Access Compliance Report

Public Rights-of-Way

(Curb Ramps)

Intersection ID: 4469	Main Street: ALVANLEY_HILLS_CT	Cross Street: DASHIEL_DR	Location:	N
ADA ID: 9BE32954AC1F	Ramp Type: Perp	Initial Pass/Fail: Fail	Overall Compliance: No	Severity Score: 18.75
Codes/Mitigation Info/Possible Solution		Field Measurements/Component Compliance

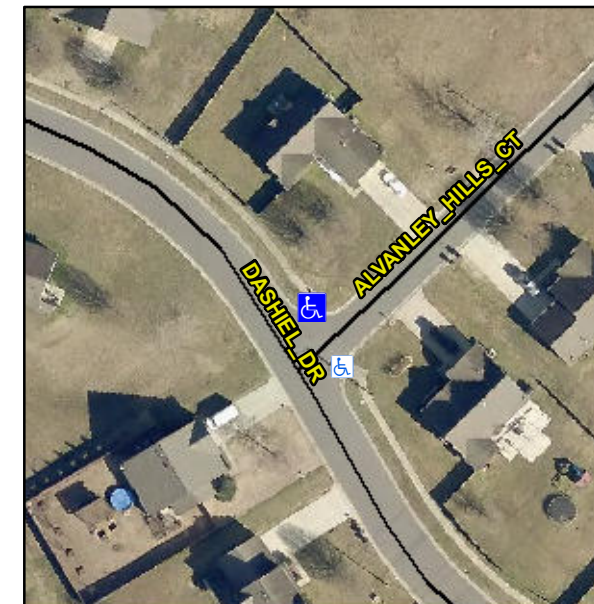
R304.5.1, R304.5.3

Compliance	Description	Data	Compliance	Description	Data
N/A	Ramp Length (in)	81.0	Yes	Ramp Slope (%)	5.9
No	Ramp Width (in)	35.0	No	Ramp XSlope (%)	3.5
N/A	Flare Type LT	N/A	N/A	Flare Type RT	N/A
N/A	Flare Slope LT (%)	N/A	N/A	Flare Slope RT (%)	N/A
N/A	Flare Traversable LT?	N/A	N/A	Flare Traversable RT?	N/A
N/A	Landing Length (in)	N/A	N/A	DWS Provided?	N/A
N/A	Landing Width (in)	N/A	N/A	DWS Contrast?	N/A
N/A	Landing Slope (%)	N/A	N/A	DWS Length (in)	N/A
N/A	Landing X Slope (%)	N/A	N/A	DWS Full Width?	N/A
N/A	Landing Curb? (Y/N)	N/A	N/A	DWS Offset (in)	N/A
N/A	Shared Landing?	N/A			
N/A	Gutter Ponding?	N/A	N/A	Gutter Slope (%)	N/A
N/A	Gutter Lip Ht (in)	N/A	N/A	Gutter X Slope (%)	N/A
N/A	Painted X Walk1?	No	N/A	Painted X Walk2?	N/A
	X Walk 1 Direction	To NW		X Walk 2 Direction	N/A
N/A	X Walk 1 Width (in)	N/A	N/A	X Walk 2 Width (in)	N/A
	X Walk 1 Slope (%)	0.7		X Walk 2 Slope (%)	N/A
	X Walk 1 X Slope (%)	4.7		X Walk 2 X Slope (%)	N/A

Remove & Replace Entire Ramp.
